Comments on #SDP-26-0002 - Planning & Zoning: Site Development Plan

Application Number: #SDP-26-0002
Application Type: Site Development Plan
Date: September 8, 2026
Address: 5109 Mitchell Mill, Rolesville, NC 27571

**MITCHELL MILL MARKET
TOWN OF ROLESVILLE WAKE COUNTY NORTH CAROLINA
SITE DEVELOPMENT PLANS
EXISTING CONDITIONS &
DEMOLITION PLAN**

DRAWING SHEET
C-6.0

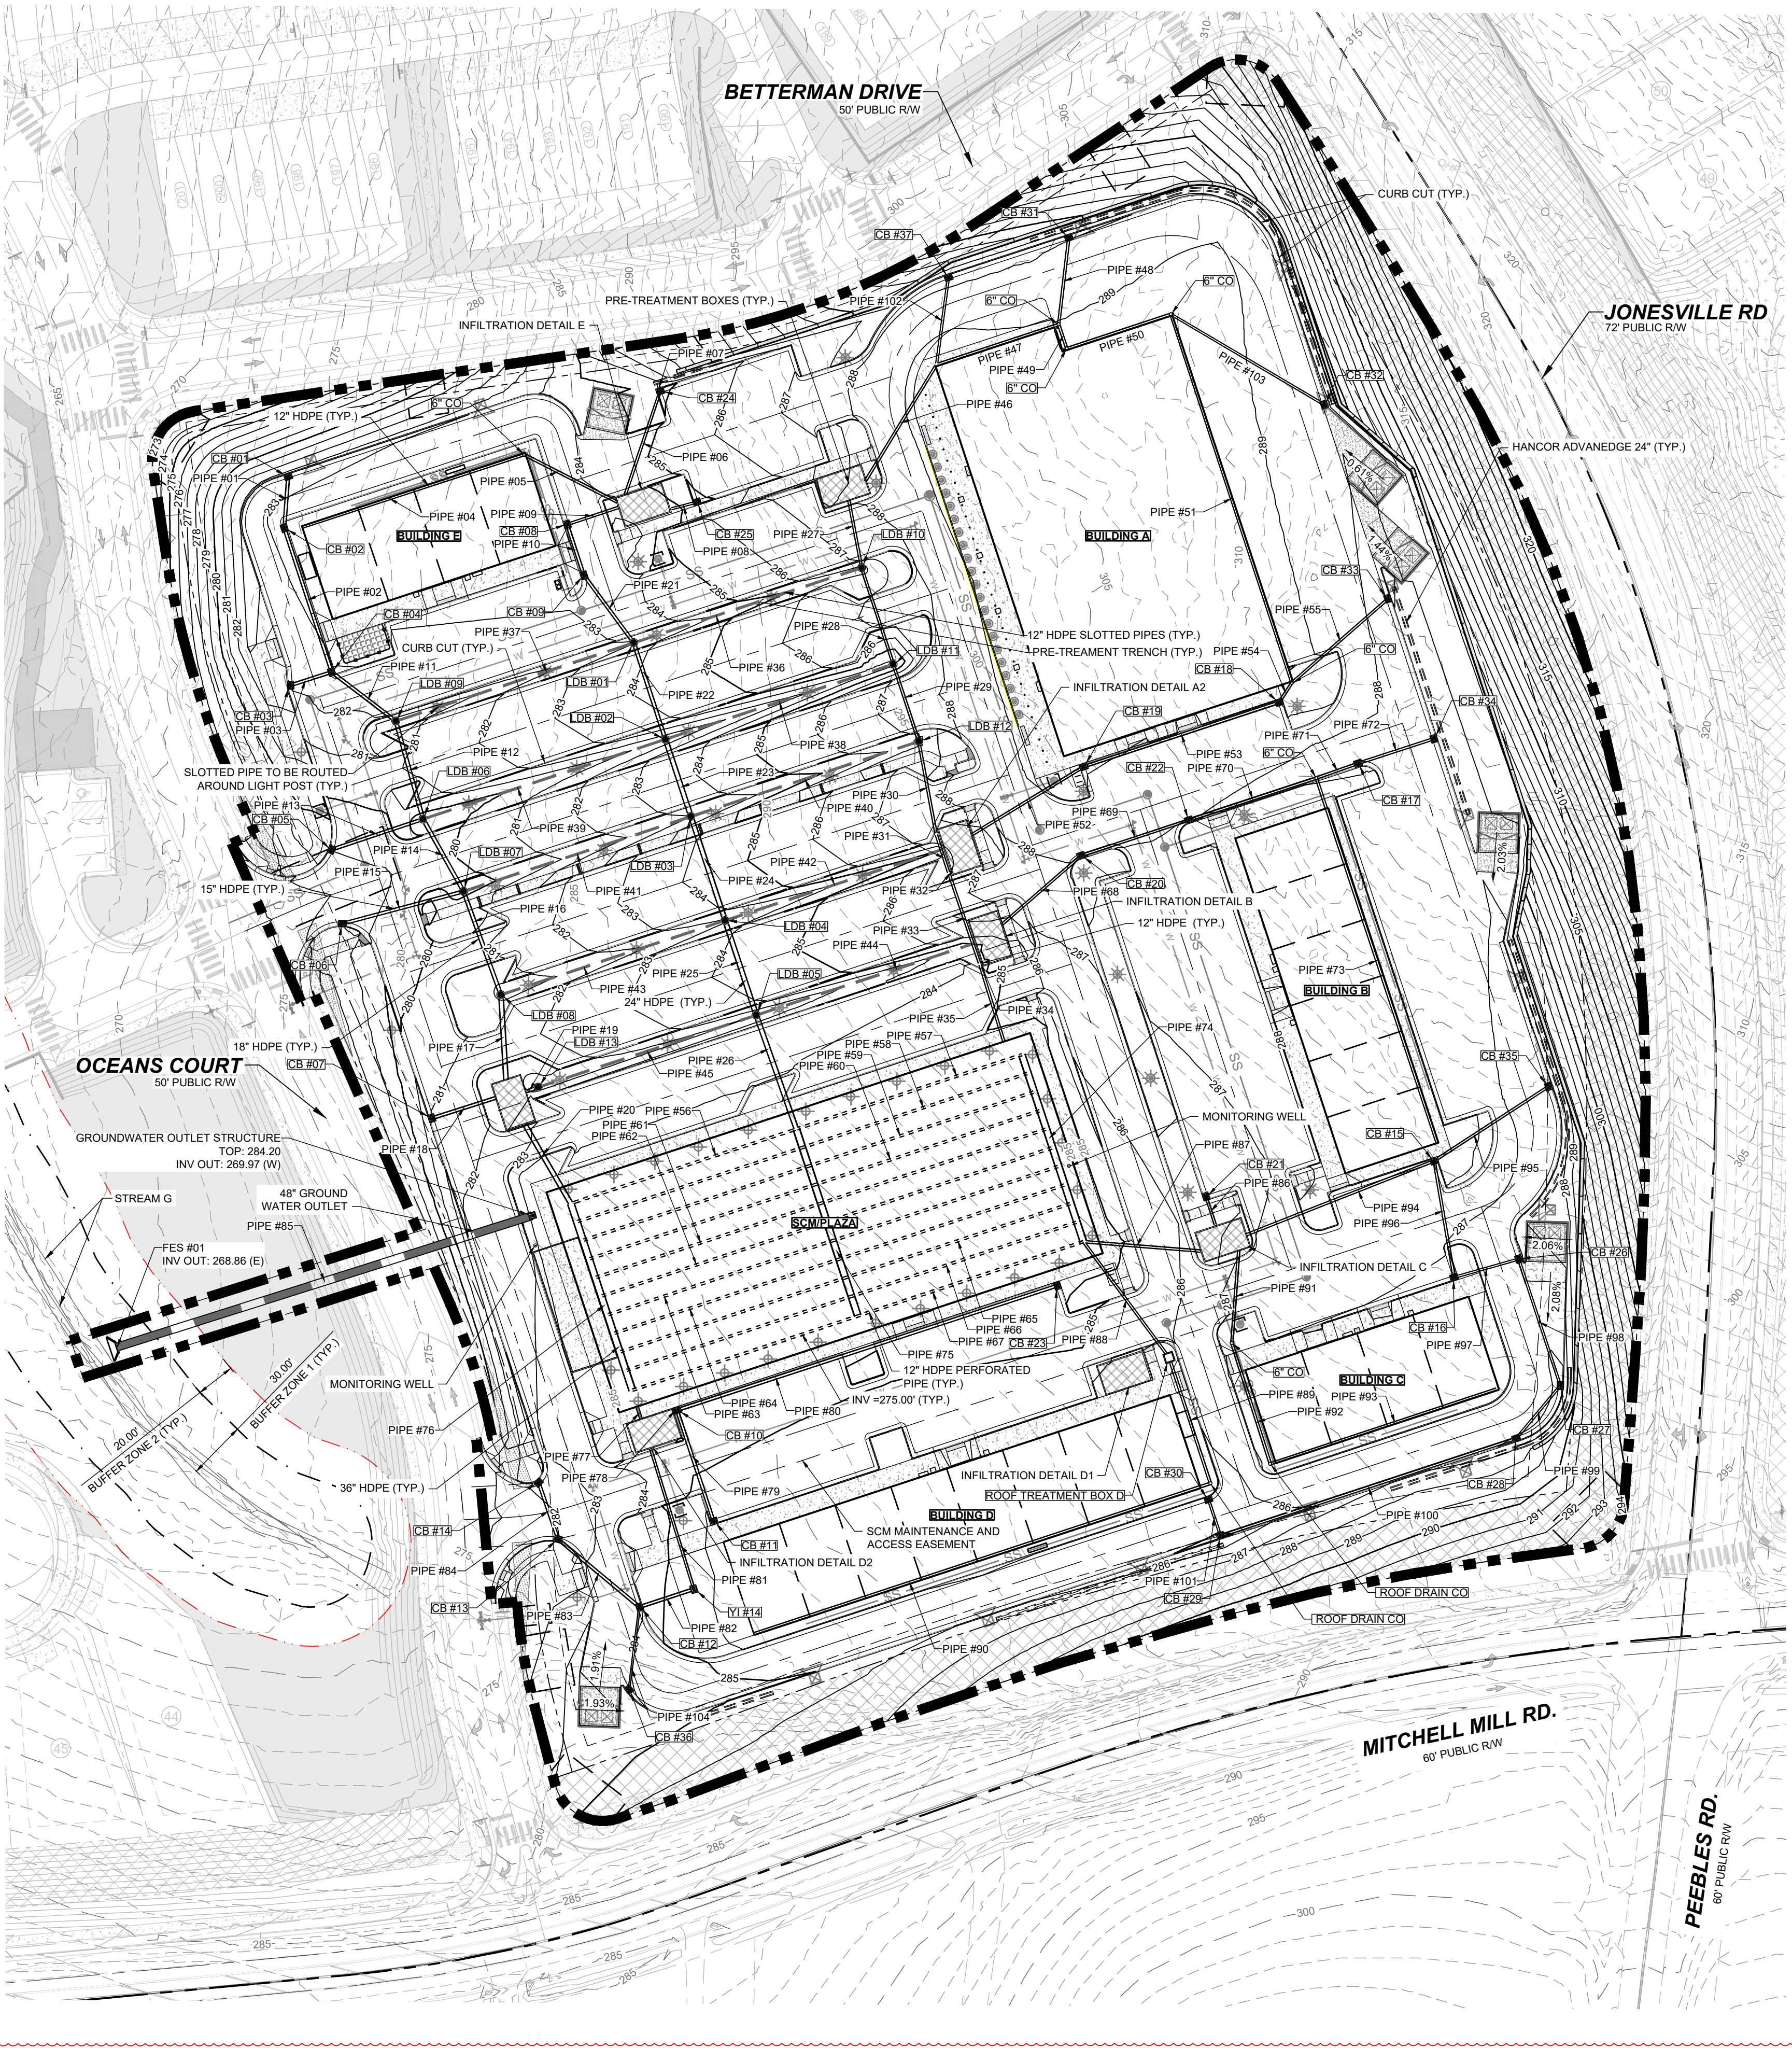
The site has been re-graded to address all drainage issues, please see Sheet C6.0 - C6.8

C-6.6

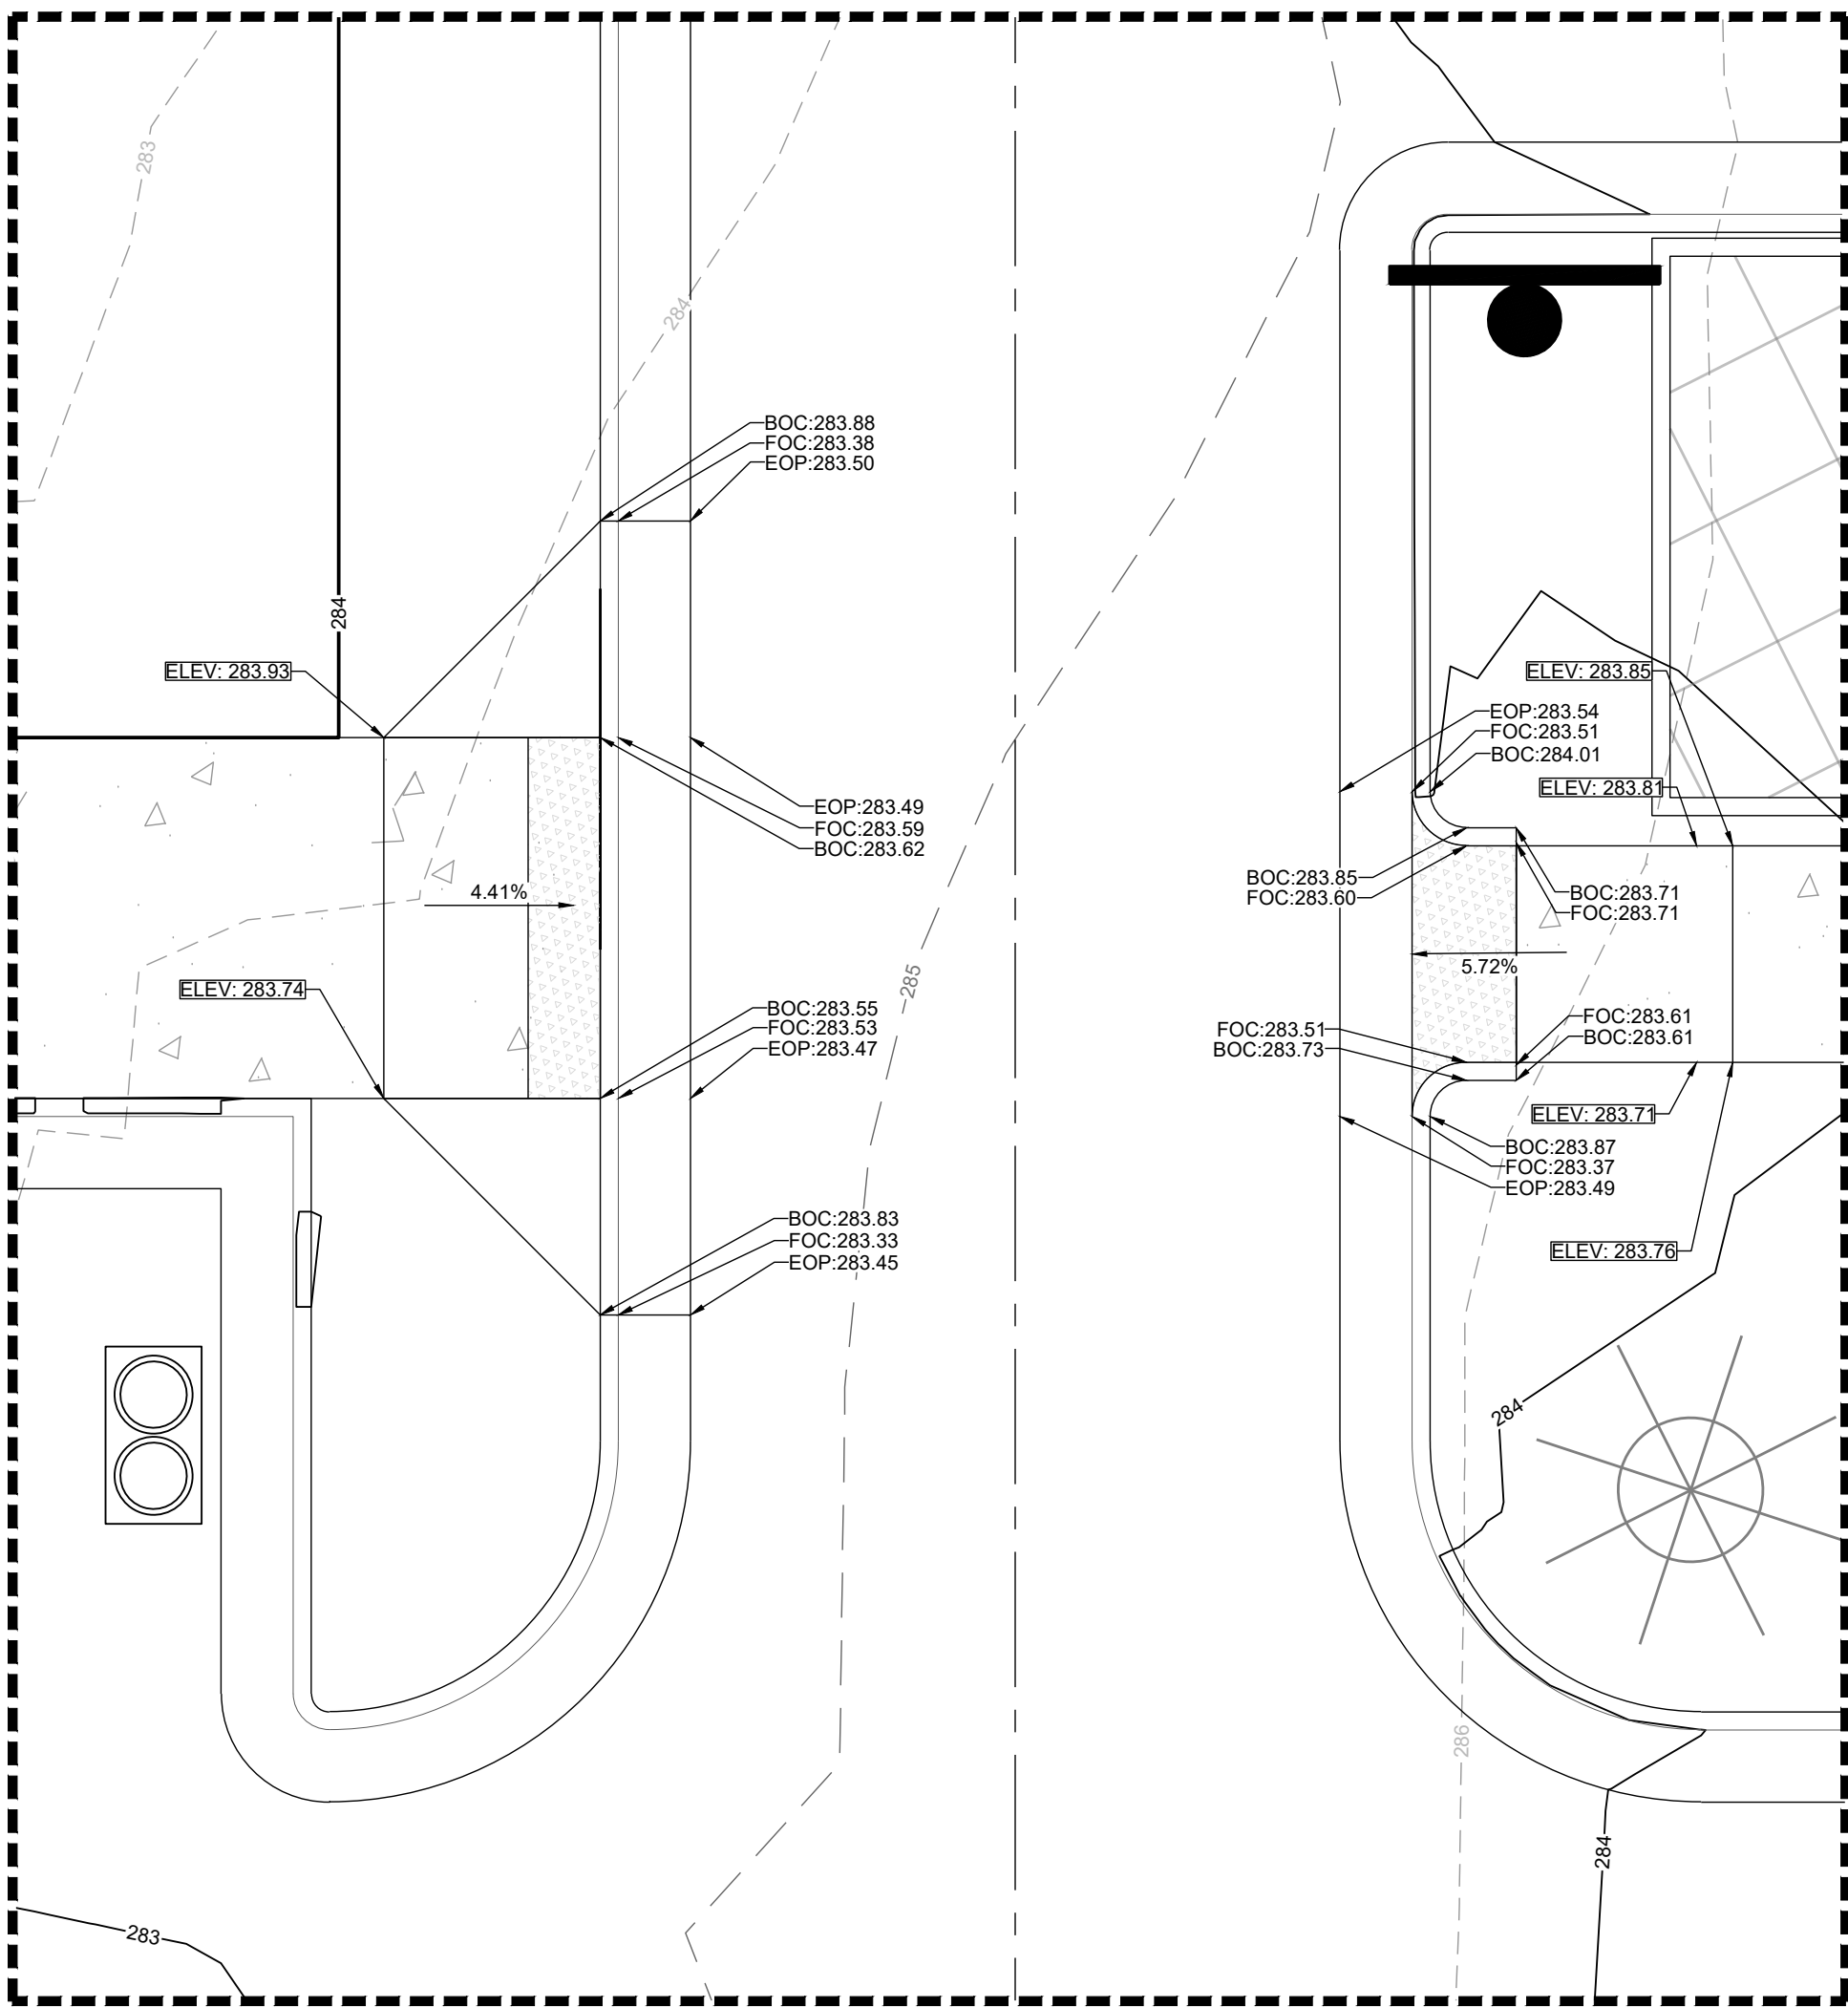
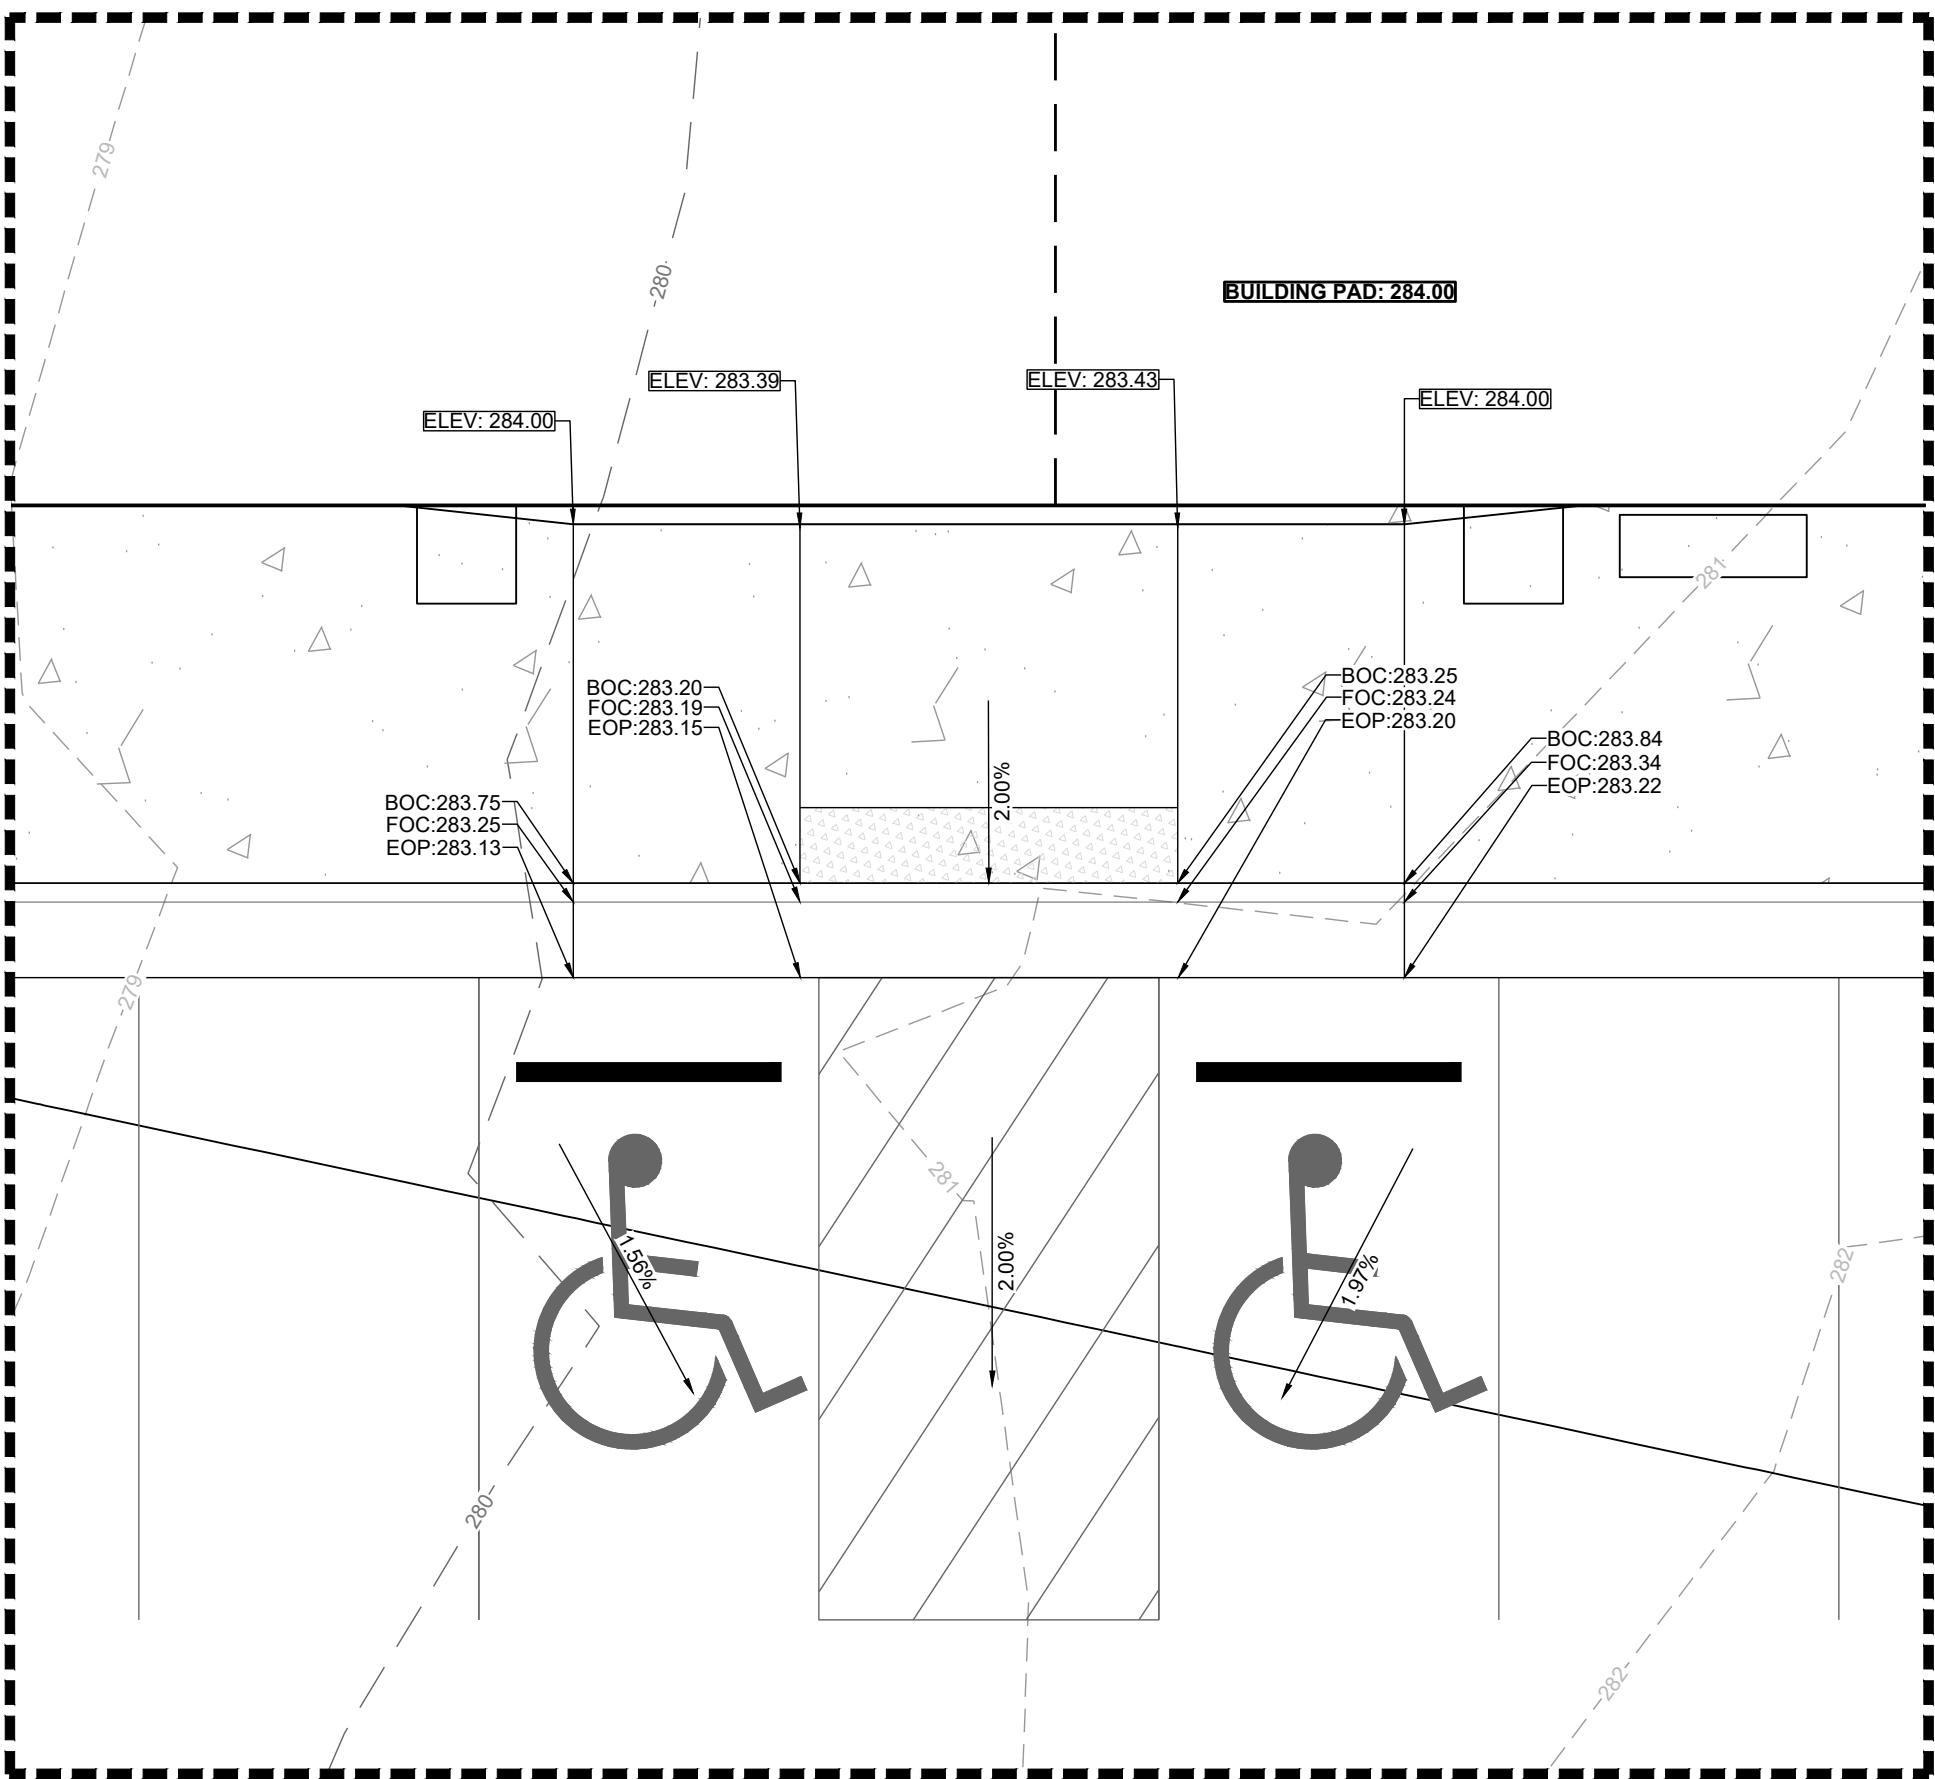
All ramps are ensured to provide a 5' x 5' landing of 2% or less, see Sheets C6.3 - C6.8
